General comments (GC)

Specific comments (SC)

Figure 1: a) Distribution of grain size statistical parameters for n=447 samples. b) Shields parameter as a function of particle Reynolds number (D_{50}) with Shields curve of critical parameter.

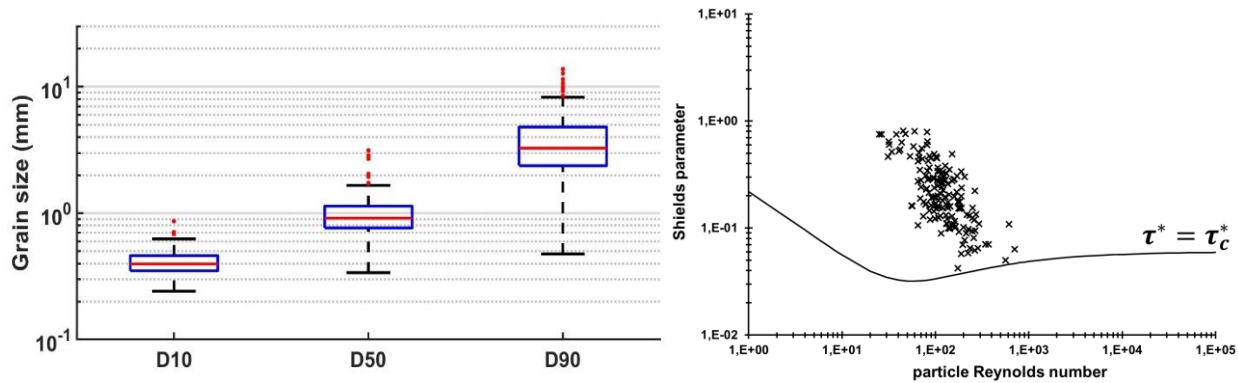
a) *“In the text, there is no info about the standard deviation of the particle's sizes of the bedload material. I would also like to see the range of the particle Reynolds number (Re_p), the shear velocity or stress and the critical shear velocity or stress. It could be also interesting if the authors give information about the reference shear stress at the study site (Parker et. al 1982). Note that this is similar to the critical shear stress but not the same.”*

As expected by the referee, we added some details about sediment characteristics in the text.

“It varies between 0.3 and 3.1 mm with a standard deviation of 0.4 mm. The D_{90} is much variable with a median value of 3.3 mm ranging from 0.5 to 15.7 mm. Hydraulic conditions at the sampling points varied with discharge; the median water depth and flow velocity are 1.6 m and 0.9 m.s⁻¹, respectively.”

Hydraulic conditions and sediment characteristics allowed to compute the Shields stress (τ^*) and its critical value (τ_c^*) for 312 samples with the following equations (figure 1b):

With g, the gravitational acceleration (9.81 m.s⁻²) and ν the kinematic viscosity of water (10⁻⁶ m².s⁻¹). The Shields stress related to the D_{50} of these 312 samples was higher than the critical Shields stress for all hydraulic conditions measured (figure 1b). The sediment (rather fine) is characterized by a significant mobility for various discharge and flow velocity conditions.

Figure 2: Adaptation of figure 3a of the original paper with point color in function of aDcp device (Rio Grande/M9).

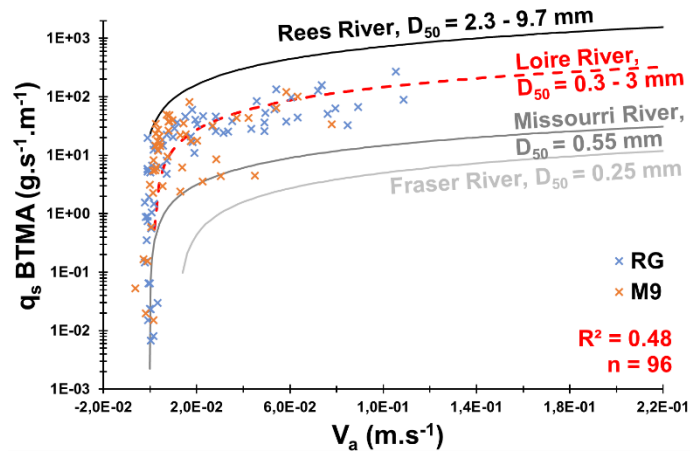
f) “In the results section, there is no distinction in the Figures between the data measured by the RDI 1200 kHz and the M9 (also which frequency). In Latosinski et al. (2017) and Conevski et al. (2020) it is clearly indicated that different ADCPs give different mean apparent bedload velocities, and it is not strictly dependent on frequency, but also to the acoustic sampling and resolution, pulse length, cell-profiling, signal processing etc. The laboratory tests are given in Conevski et al. (2019) and Conevski, et al. (2020) also confirm and elaborate on these issues.”

The scope of this paper is not to study the impact of frequency or pulse length on the apparent velocity. In that way, we did not mention these details in the figure 3a. But you can find details in the appendix B. About 55% of the dataset was measured with the RDI Rio Grande (1.2 kHz). You can find below the figure 3a adapted with the reference of the used device. It is clear that if we had been able to use the same device during all measurements it would be better.

Figure 3: View of a multibeam longitudinal track measured on the study site (scale=about 300 m long to 4 m width).

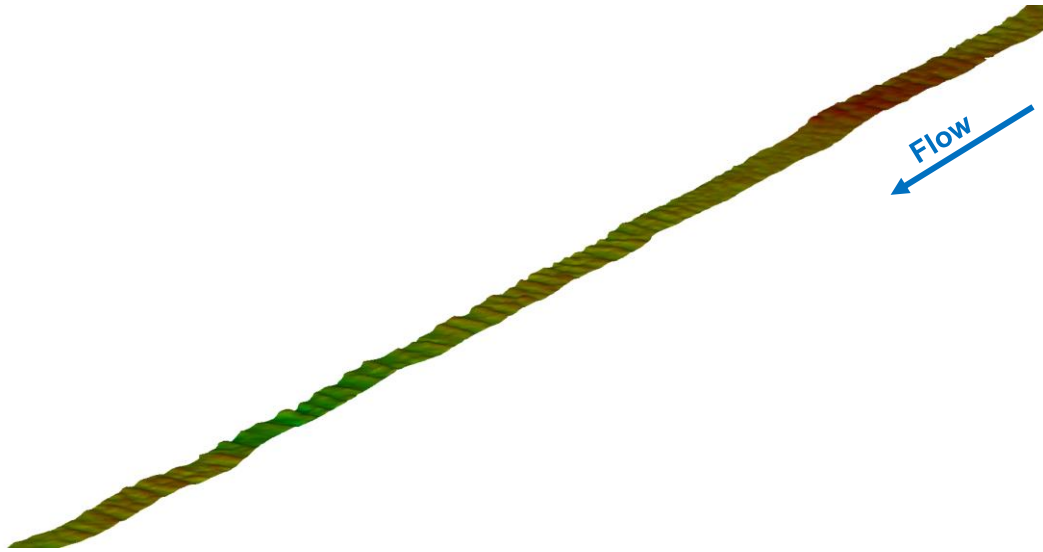
b) “On the other hand, the DTM method that you use is built based on well-developed 2D dunes. Could you please elaborate on this issue? I am afraid that maybe only the dune measurements in the thalweg zone would be most reasonable to use in the comparison with the other two techniques?”

We understand your comment. On the Loire River the DTM method was used on several sites because the 2D dunes were recognized on all these sites (multibeam echosoundings). Please see the following publications: Claude et al., 2012 & 2014; Rodrigues et al., 2012 & 2015; Wintenberger et al., 2015. If dunes are present in the thalweg for all discharge conditions, they develop rapidly on the back of bars since these latter are submerged (Le Guern et al., 2019). That means that most of the riverbed is covered by dunes when bars are submerged. Although the significant width of the channel makes difficult to perform multibeam echosoundings, we did a couple of them, in 2018, on some longitudinal tracks located on the back of bars present in the study site (please see figure below). As it can be seen on this figure, the dunes are clearly 2D dunes for the 3 longitudinal tracks presented.

Figure 4: Correlation between acoustic power integrated above 15 kHz and above varying lower limits (1, 2, 5 and 10 kHz).

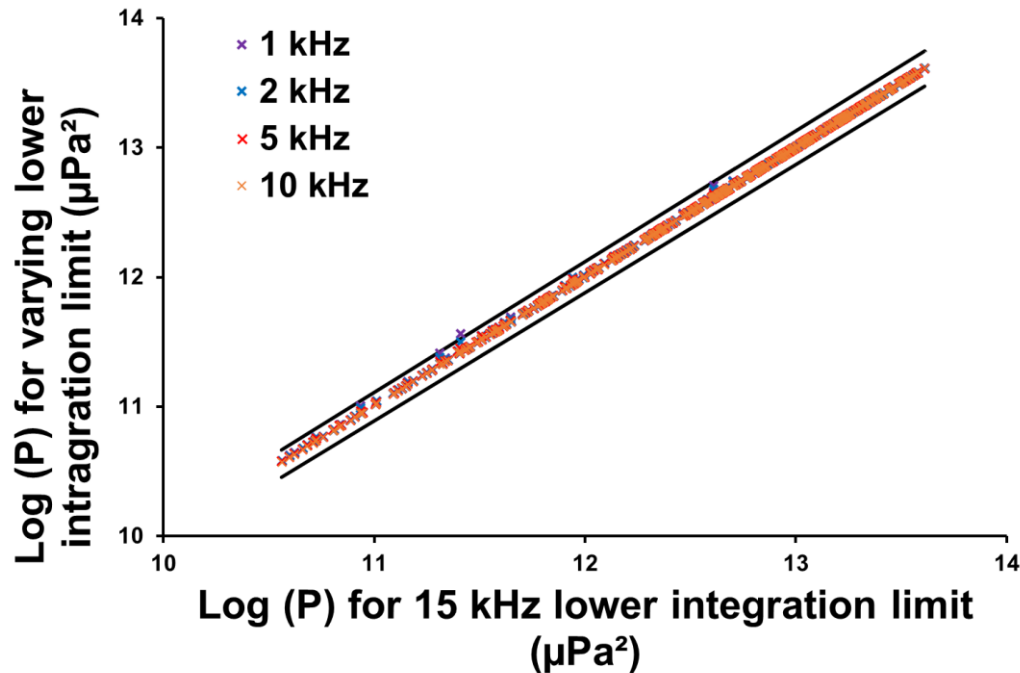
a) “What is the advantage of drifting of the hydrophones? Isn't there less ambient noise (not bedload flux noise) if they stay fixed? Ok, I read in the Geay et al. (2020) that it is actually the opposite... I did not find a comparison of both cases. How was drifting performed and why the waves hitting the boat or produced by the boat did not affect the measurements?”

By moving at the water velocity, the ambient noise is reduced in comparison with a fixed position. The drift is performed as follow:

The sound of waves and the boat are reduced when drifting. Among all our hydrophone records (448), we noted that, only one survey (performed during high wind conditions) was characterized by waves oriented upstream and increasing the ambient noise. However, these noises do not affect acoustic power measurements because they produce noise in the low frequency band (<2 kHz) and we integrated bedload noise in higher frequency band (15-350 kHz). We also checked

if the lower limit for integration of the PSD affects the overall acoustic power recorded (Artus and Bouchard, 2021). The results of this work is clear: we miss a very small part of the bedload signal by integrating at 15 kHz. Among all the measurements, only one sample is greater than 1% of the reference acoustic (Figure 2). As expected, this sample appears when we decrease the integration lower limit to 1 kHz and it correspond to the windy weather conditions that we mentioned above.

Figure 5: sensibility of V_a post-processing to estimate BTMA bedload rates with both kinematic models employed in the paper, a) Equation 4; b) Equation 5.

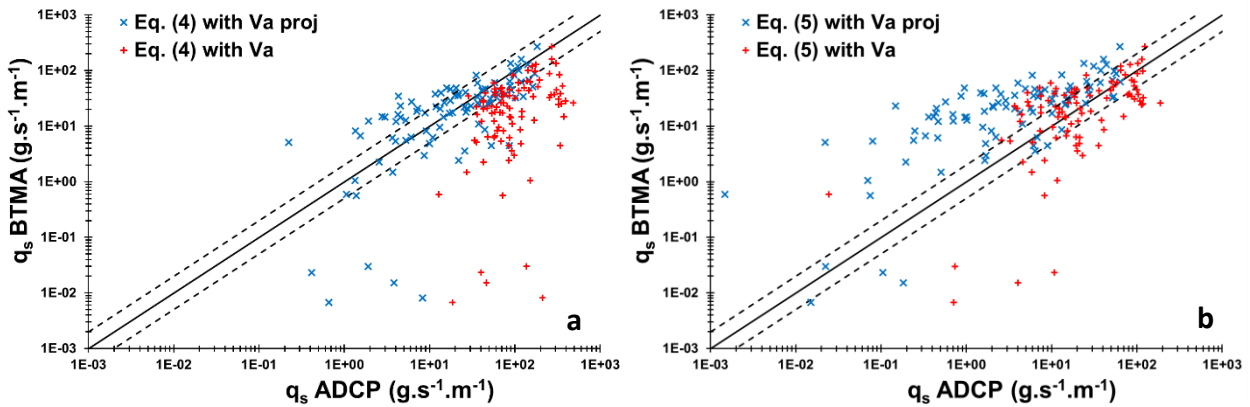
“L124-L130: These are both kinematic models and essentially both describe a unit volume with its specific density moving with unit velocity. The first one is an assumption that the ADCPs are more sensitive to the particles and particle numbers and that by assuming characteristic particle V_a would represent average in all 4 acoustic footprints. Considering g.c. 3c it is rather strange that you get better matching for Eq4 in Fig3b. But then the assumptions for Eq. 5 and the filtering are not correctly applied.”

We applied this equation based on a recent literature review (Holmes, 2010; Latosinski et al., 2017; Villard et al., 2005). As a starting point, we chose to fix the bedload concentration to the maximum bedload concentration according to van Rijn (1984) to compare to the computations performed for BTMA and DTM bedload rates. The thickness of the active layer was defined by van Rijn's (1984) equation as the saltation height. There was a mistake in the previous version of the manuscript on equation 6 ($d_s = 0.3 D_*^{0.7} T^{0.5} D_{50}$). Fortunately this mistake was only in the text and not in the dataset. According to yours seminal comments (GC3j, SC19, SC20, SC33, SC35) we decided to analyze the effect of the apparent bedload velocity projection on kinematic models (Eq. 4 and Eq. 5). As expected, the concentration of bedload layer is probably overestimated when it is fixed to maximum bedload concentration ($c_0 = 0.65$), so, following your suggestion, we computed bedload concentration according van Rijn (1984):

These results bring us to consider these two options of apparent bedload calculation in both kinematic model. Therefore, we could discuss the availability of our data processing and its consequence for using in kinematic models. The calibration between BTMA and aDcp with raw apparent bedload velocity is not possible and data need a filtering procedure as you proposed in GC3a. We propose to add:

- Equation of bedload concentration with appropriate modification in the Materials and Methods section (paragraph 3.2).
- Figures 5a and 5b in the Results section 4.1. with the description of these results. “Computed bedload layer concentration (Eq. 7) varies between 0.005 and 0.1 (0.03 in average). Bedload layer thickness (d_s) (Eq. 6) ranges between $1D_{50}$ and $7D_{50}$ ($5D_{50}$ in average). Bedload rates computed using Eq. (5) underestimate BTMA bedload rates with only 24% of the dataset in the discrepancy ratio (Figure 4b). By considering apparent bedload velocity without projection over flow direction, the kinematic model (Eq. 5) better estimates BTMA bedload rates with 41% of the dataset in the discrepancy ratio. Conversely, using raw apparent bedload velocity in the Equation 4, leads to only 33% of
